Maxtor Corporation
500 McCarthy Boulevard
Milpitas, CA 95035 USA

To: T10 CAP Working Group
Contact: Mark Evans
Phone: 408-894-5310
Email: mark_evans@maxtor.com
Date: 10 January 2003

Subject: SAM-3, SPC-3, and SBC-2 power conditions proposal

Figure PC – Power condition state machine

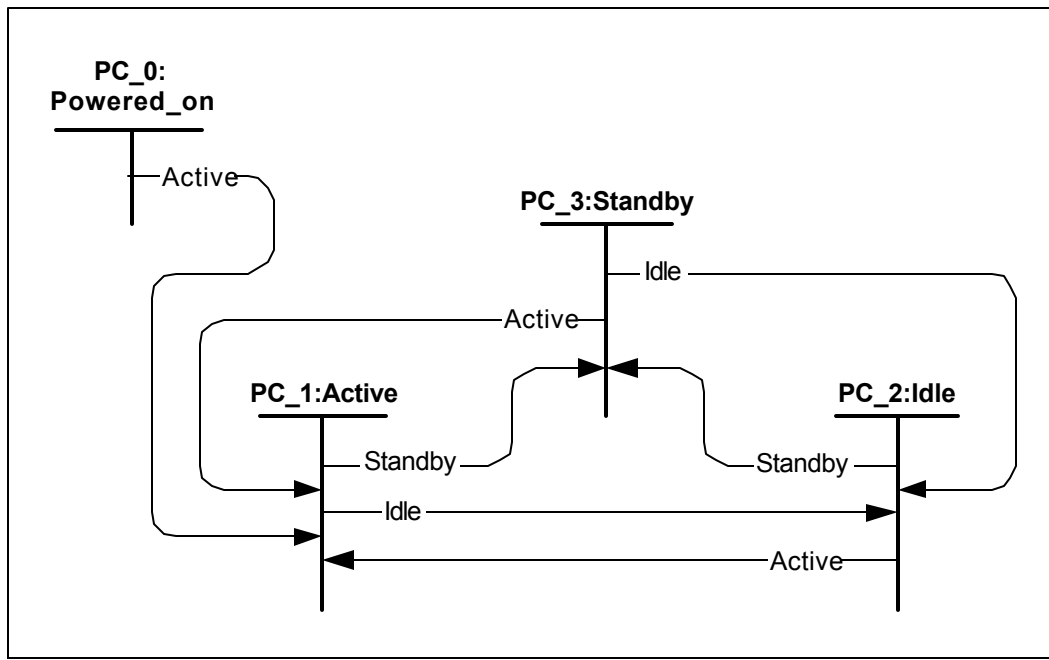
In SPC-3: Replace subclause 5.8 with the following:

The power condition state machine (PC) describes the logical unit power states and transitions resulting from Power Condition mode page settings.

The PC states are as follows:

- a) PC_0:Powered_on (see 5.8.2.2) (initial state);
- b) PC_1:Active (see 5.8.2.3);

- c) PC_2:Idle (see 5.8.2.4); and
- d) PC_3:Standby (see 5.8.2.5).

The PC state machine shall start in the PC_0:Powered_on state after power on.

Figure PC describes the PC state machine.

Figure SSU – Power condition state machine for logical units implementing the START STOP UNIT command

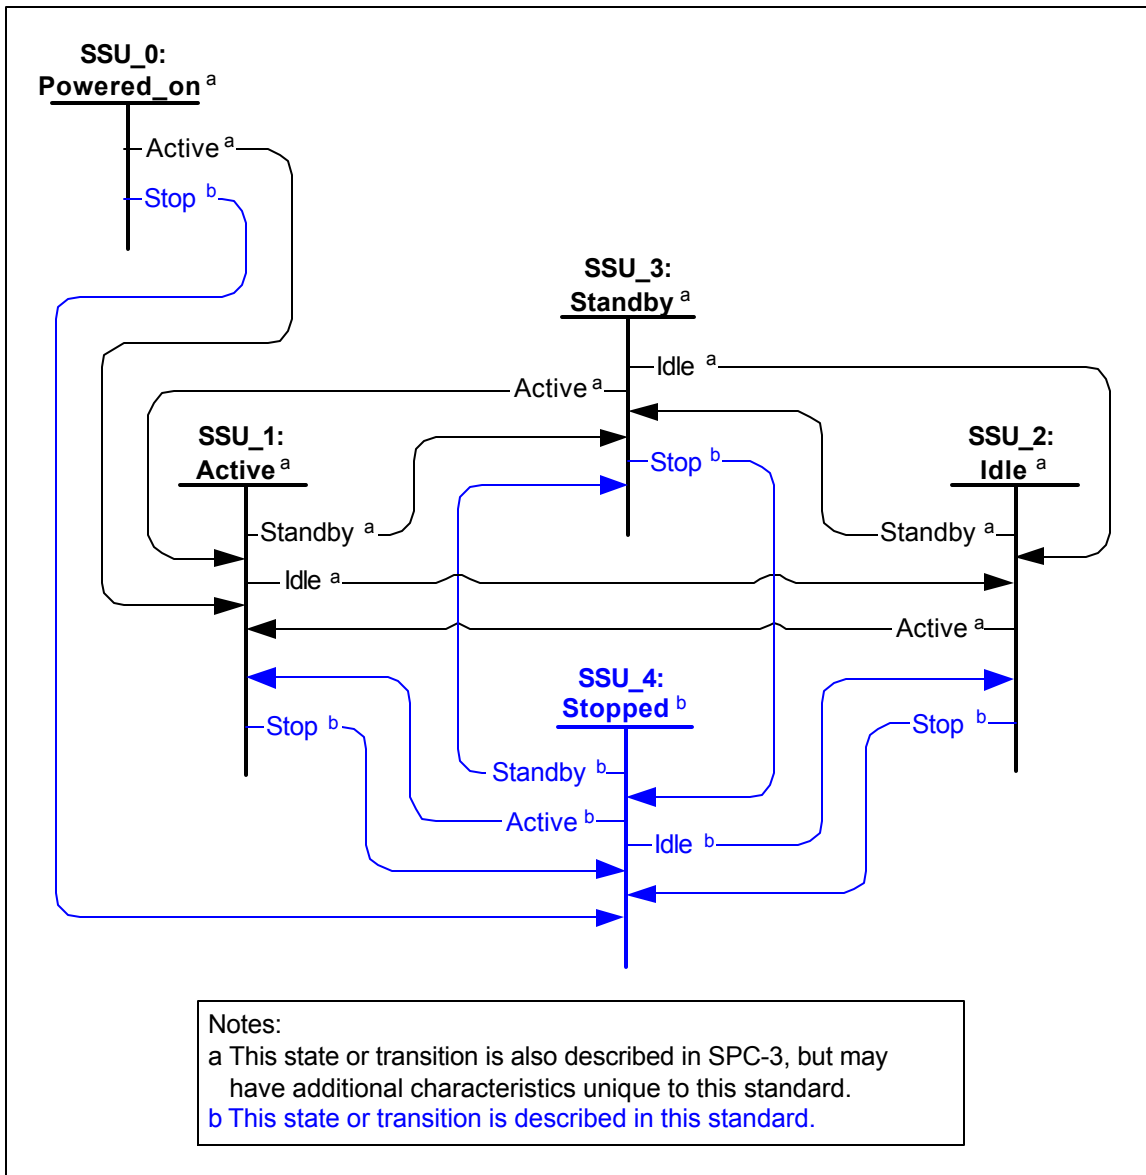
In SBC-2: Add the following in the Models clause

The power condition state machine (SSU) for logical units implementing the START STOP UNIT command describes the logical unit power states and transitions resulting from settings by the START STOP UNIT command and settings in the Power Condition mode page (see SPC-3).

The SSU states are as follows:

- a) SSU_0:Powered_on (4.2.1.x.2.2) (initial state);
- b) SSU_1:Active (4.2.1.x.2.3);
- c) SSU_2:Idle (4.2.1.x.2.4);
- d) SSU_3:Standby (4.2.1.x.2.5); and
- e) SSU_4:Stopped (4.2.1.x.2.6).

The SSU state machine shall start in the SSU_0:Powered_on state after power on.

Note: The SSU state machine is an enhanced version of the Power Condition state machine described in SPC-3.

Figure SSU describes the SSU state machine.
